CORRIGENDUM - 1 TO TENDER SPECIFICATION BHEL PSSR SCT 1742 - DT: 23.06.2018

TENDER SPECIFICATION BHEL PSSR SCT 1742 - Road formation works up to WBM level inside plant area at BHEL 2X660MW Ennore SEZ STPP, Vayalur BR PO, Minjur Tamilnadu State

DETAIL - B

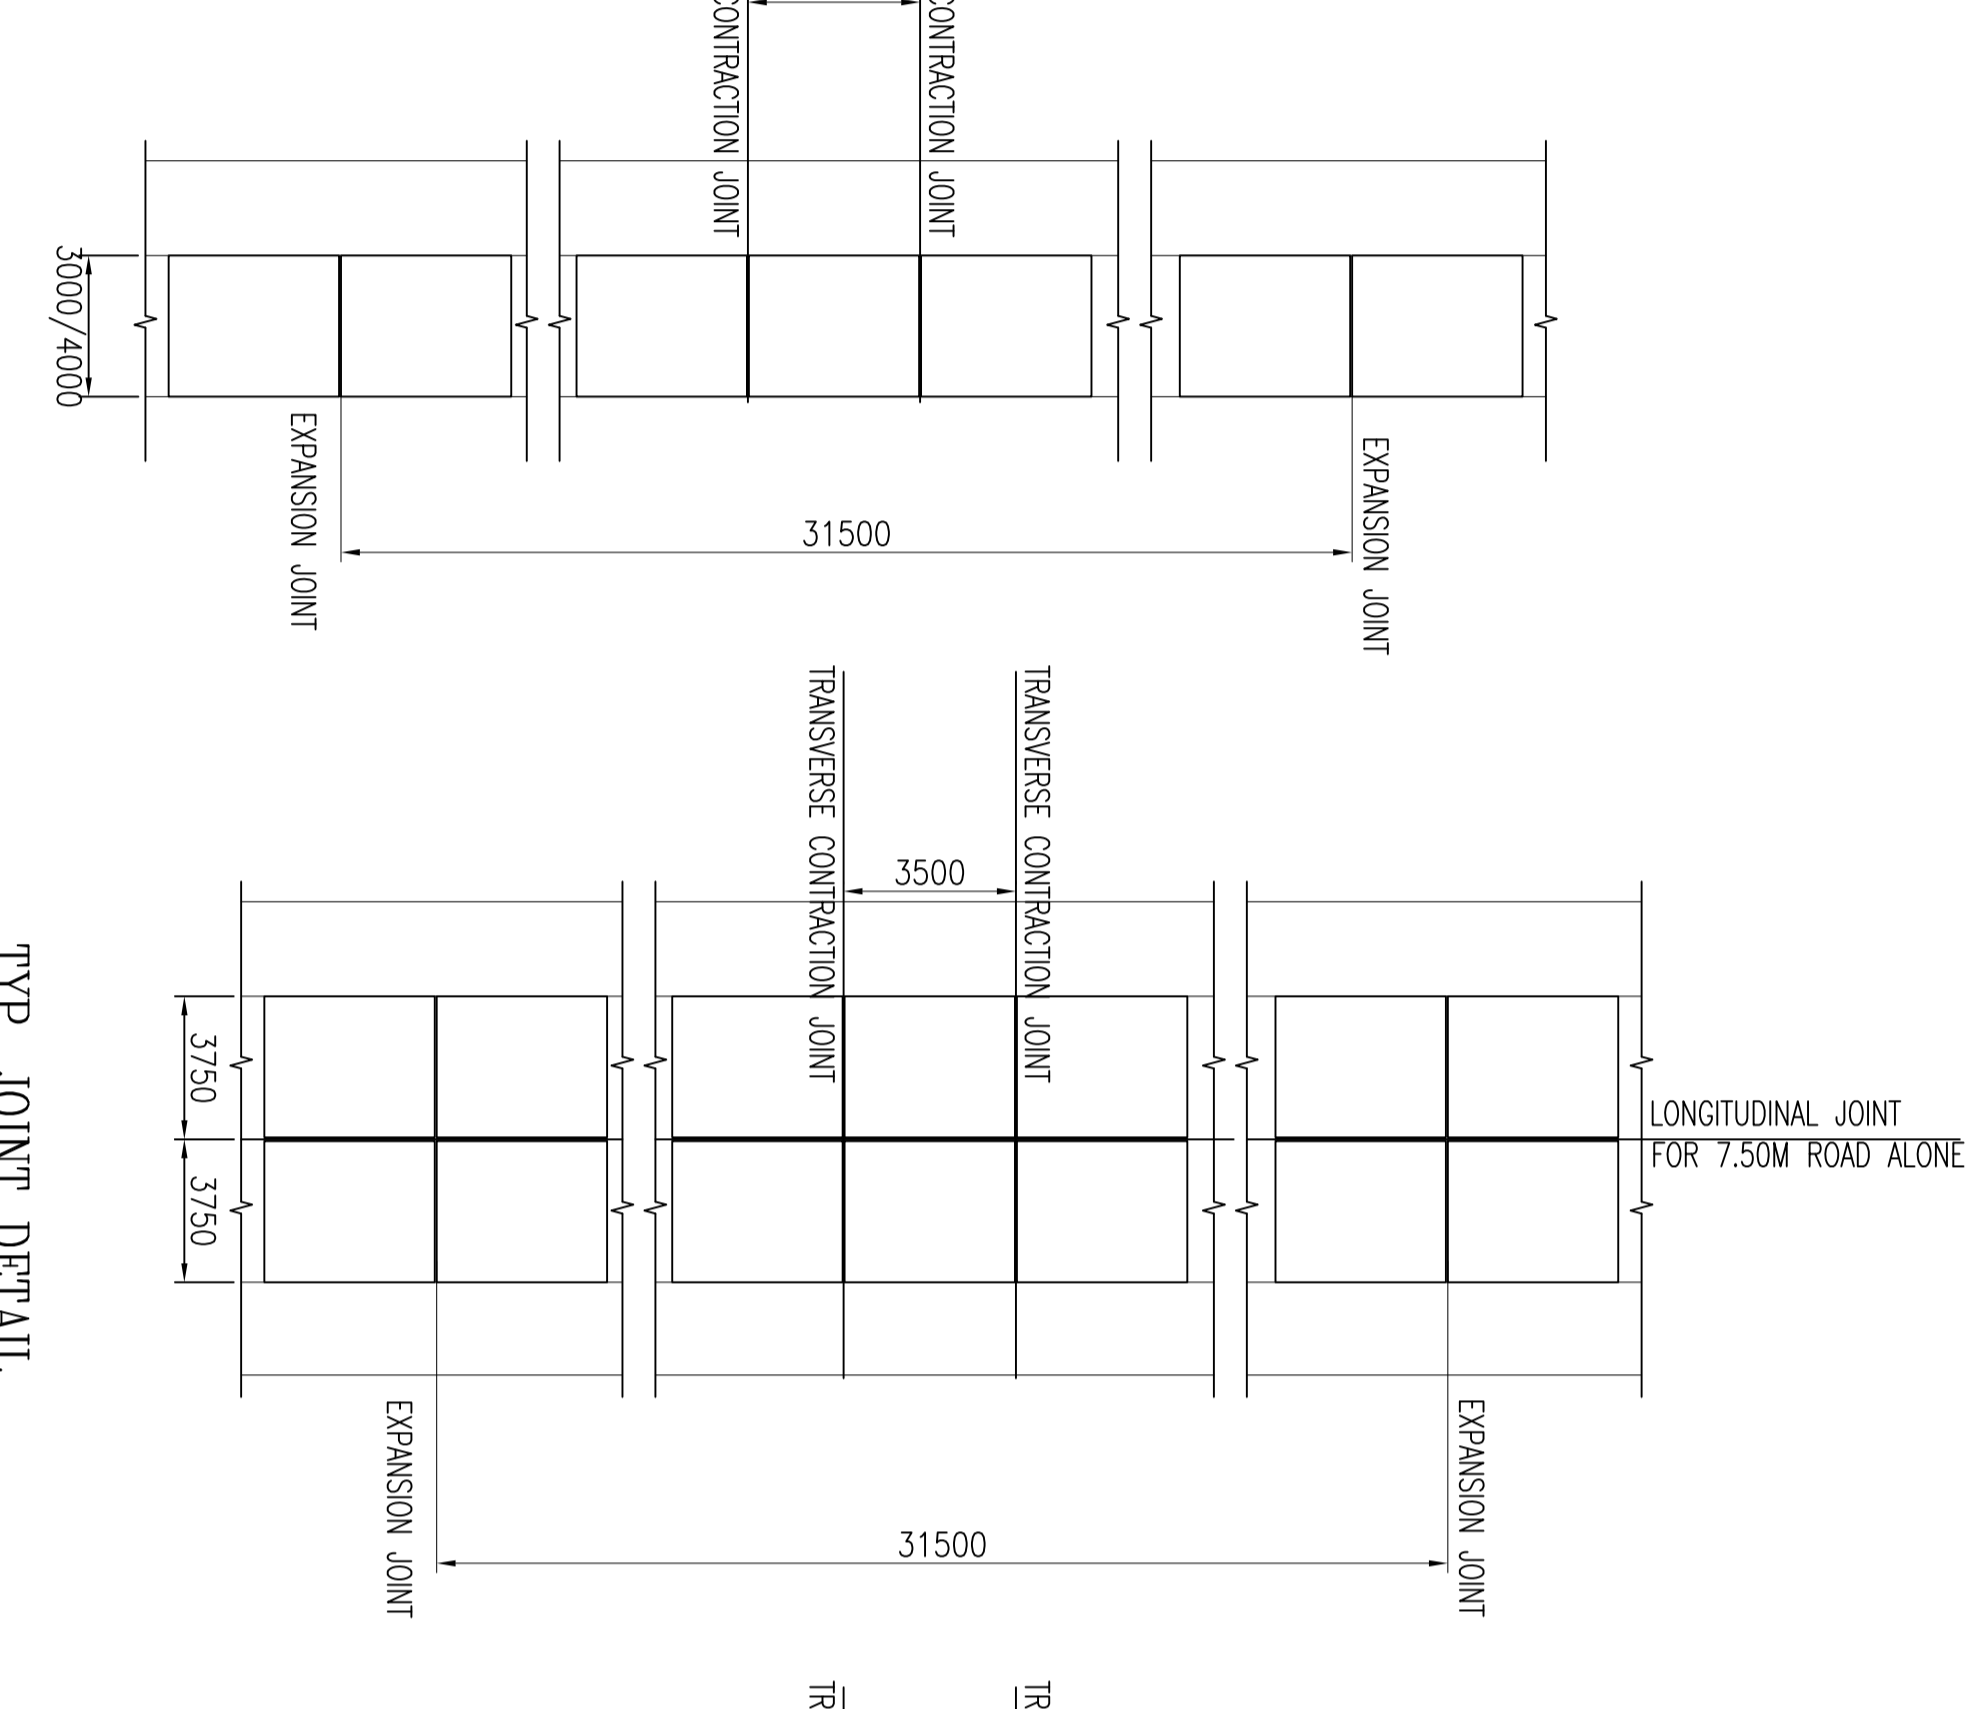
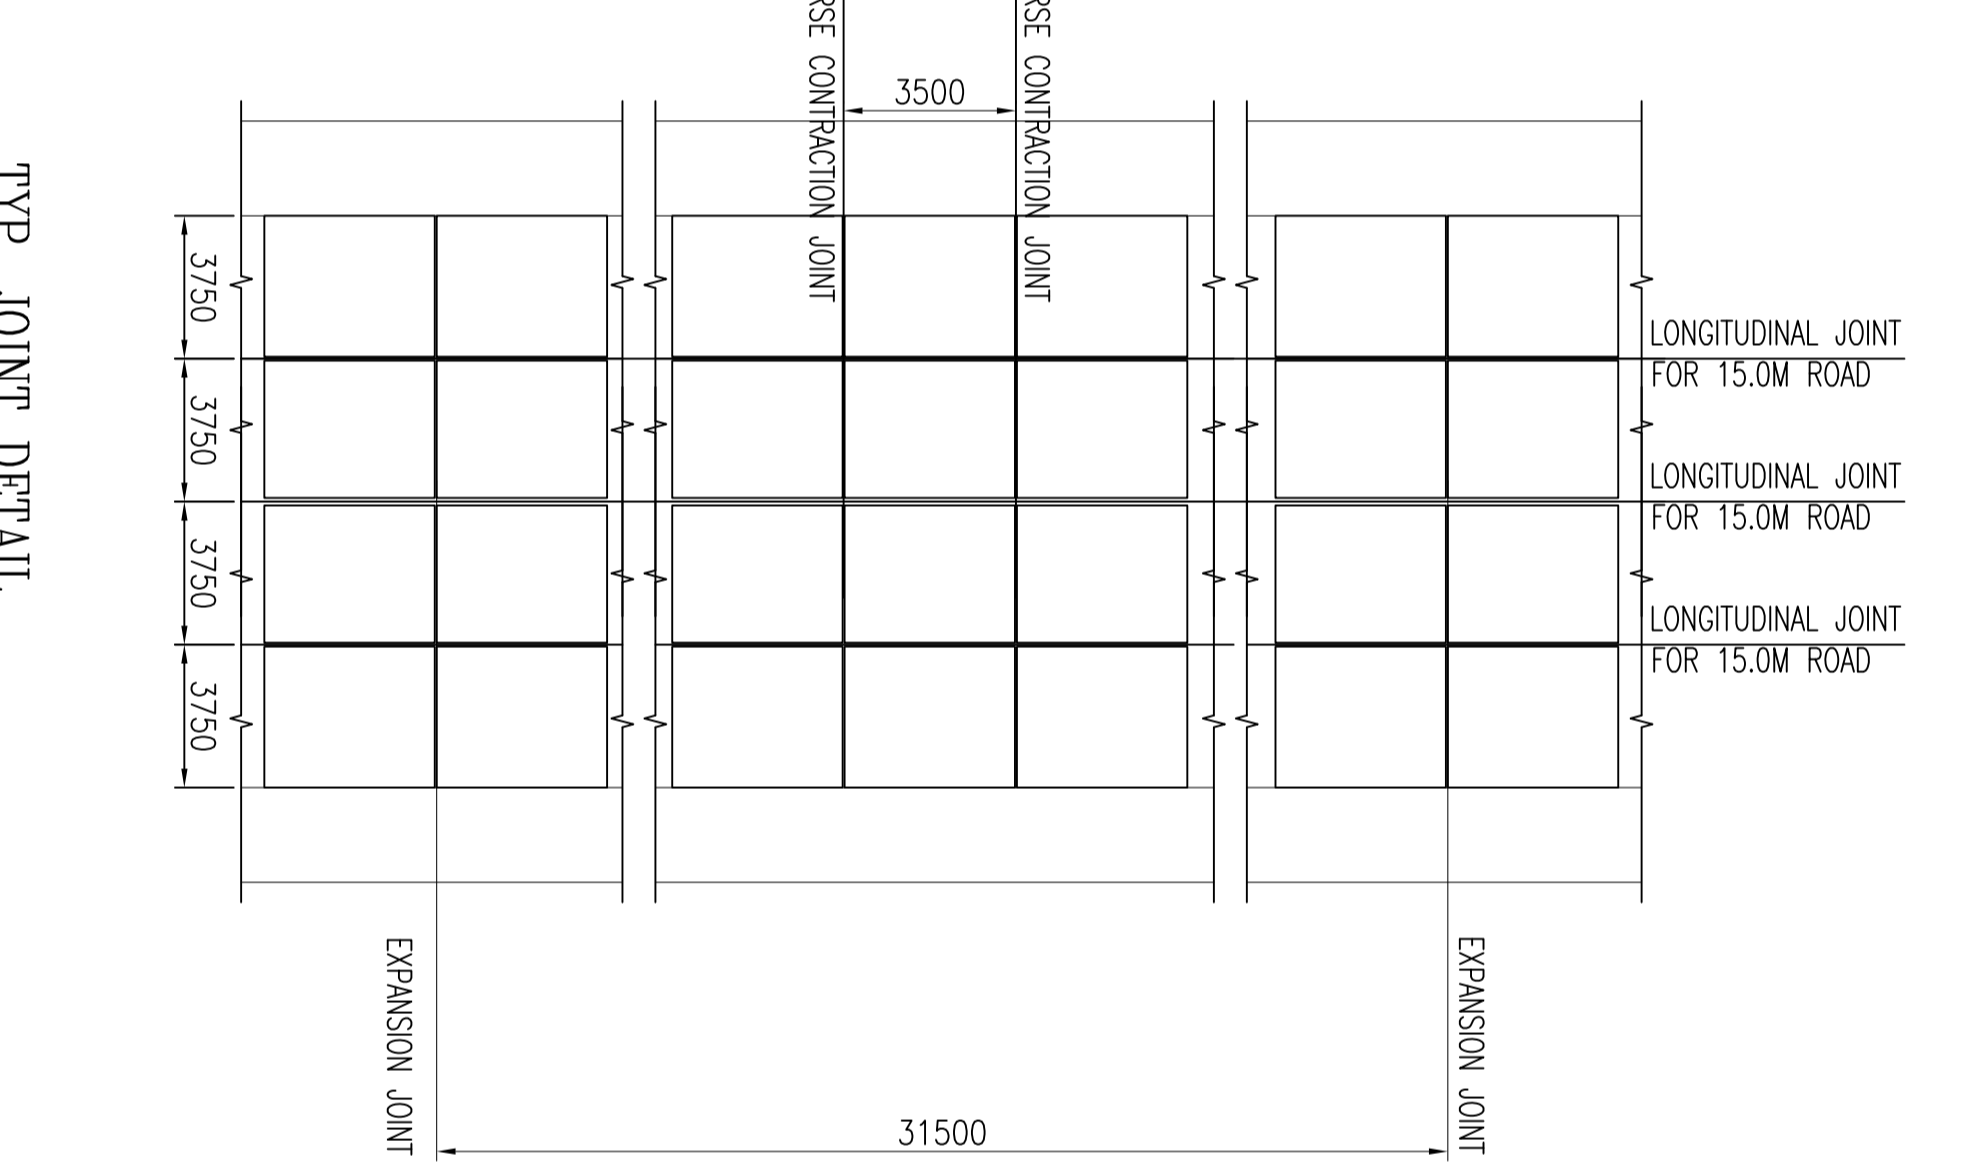
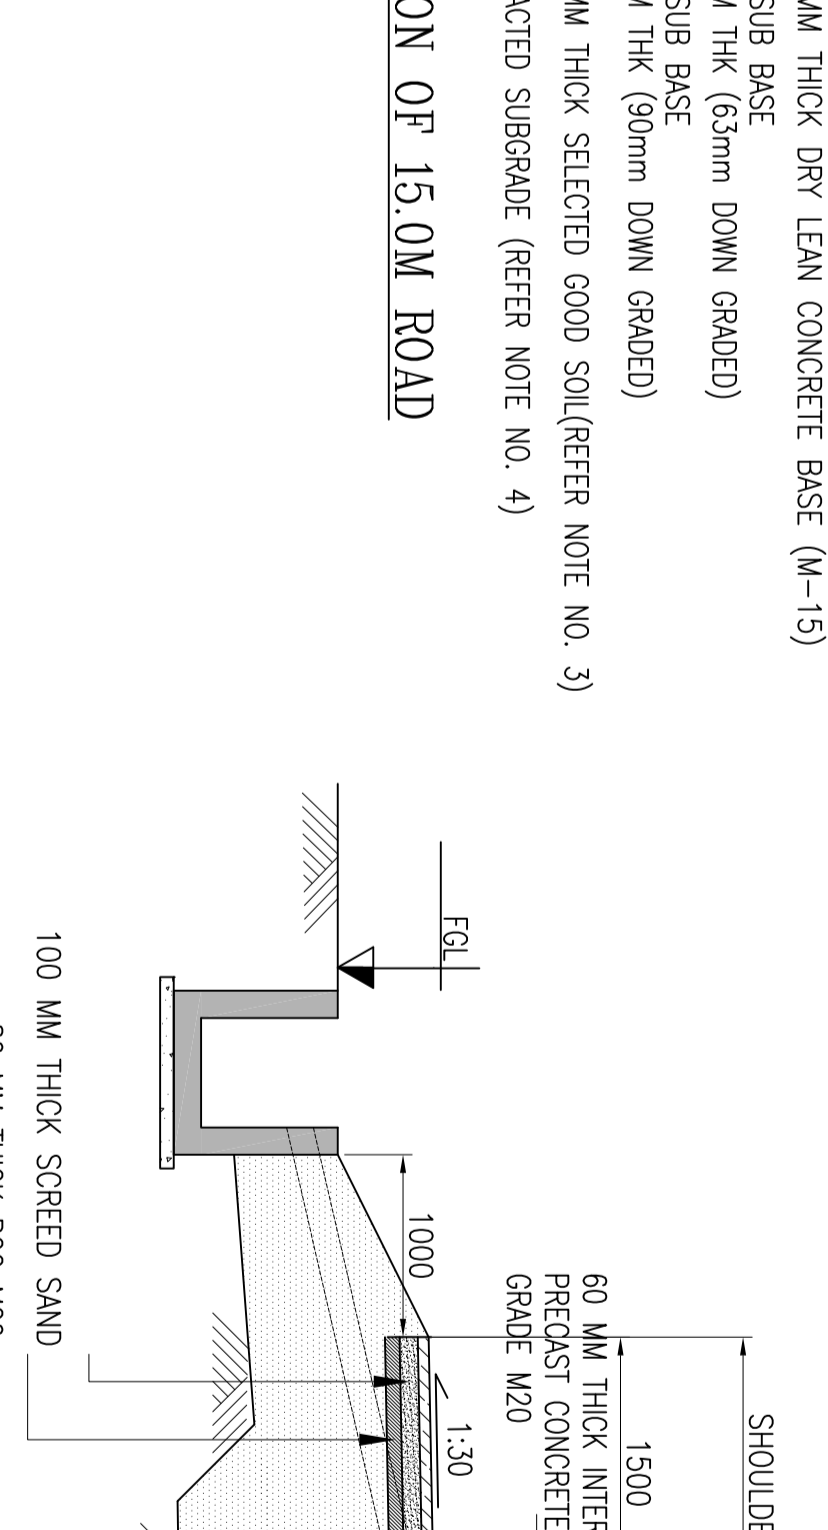
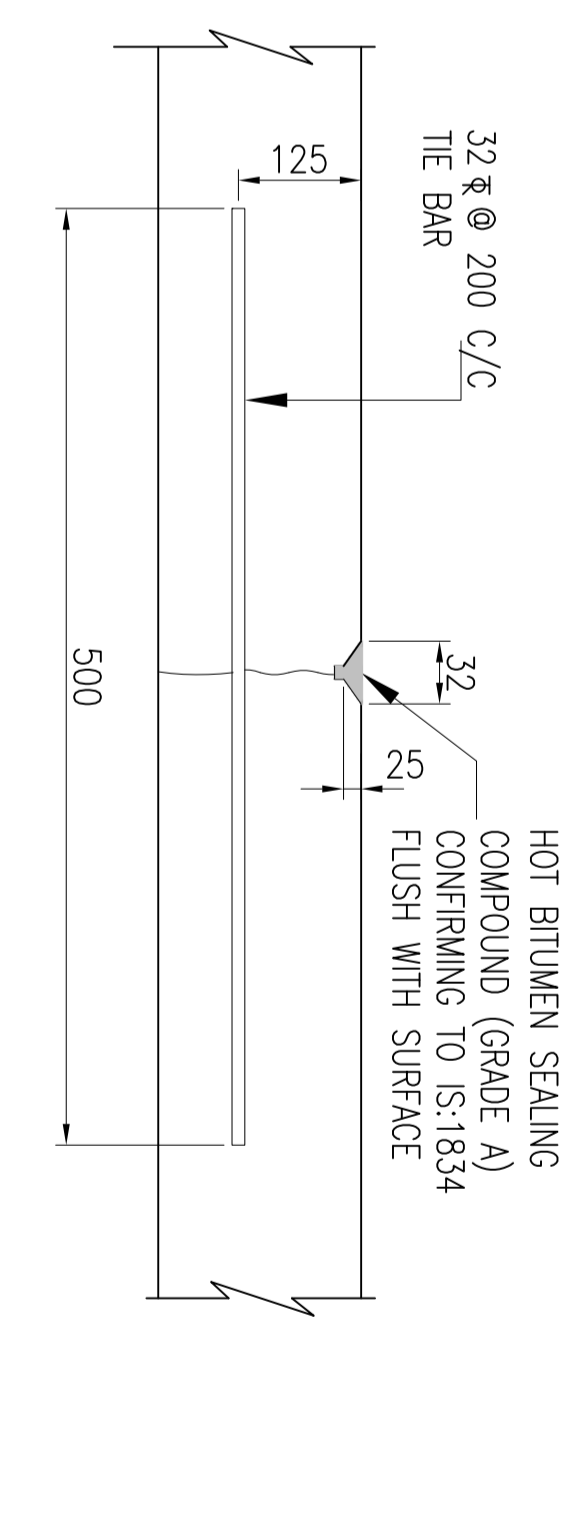
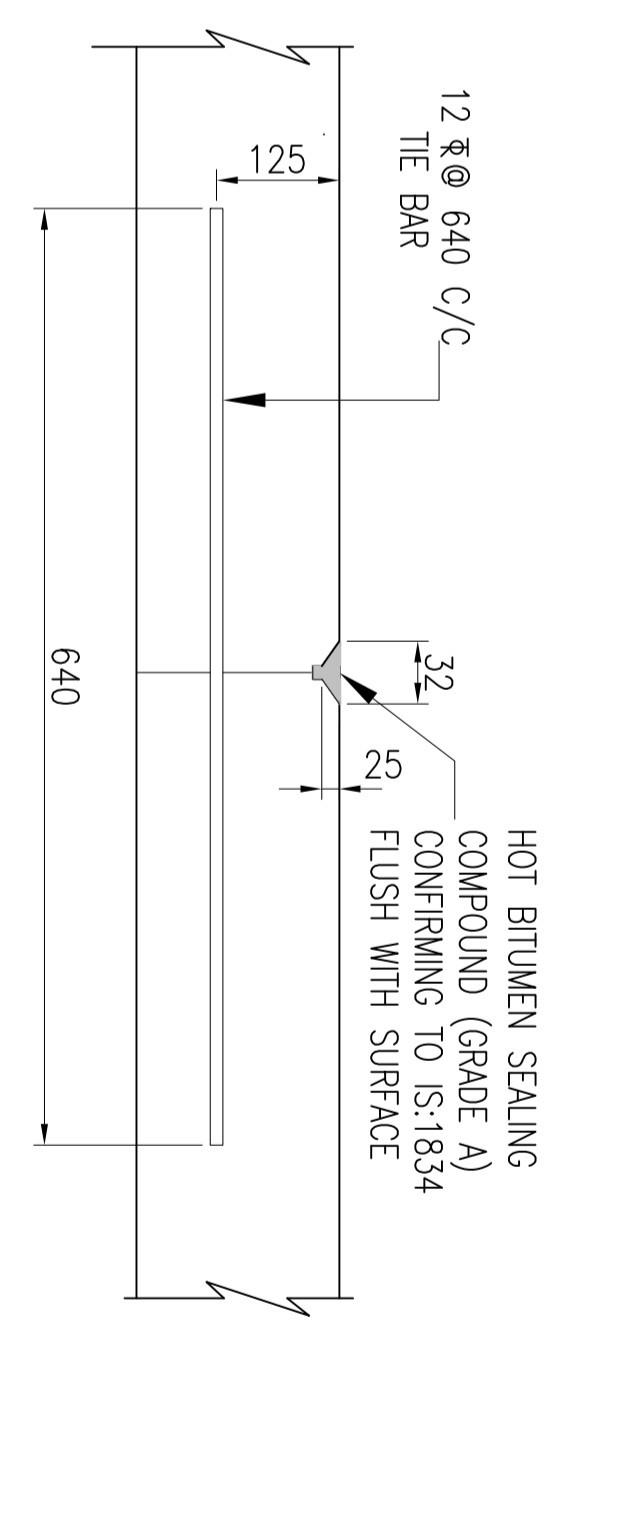
<u>Sl. No.</u>	<u>Bidder's Query</u>	<u>BHEL reply</u>
1	Section drawings for Road works shall please be provided.	Drawing (one page) of 'Plant Road cross section & details' for the said tender attached with this Corrigendum.
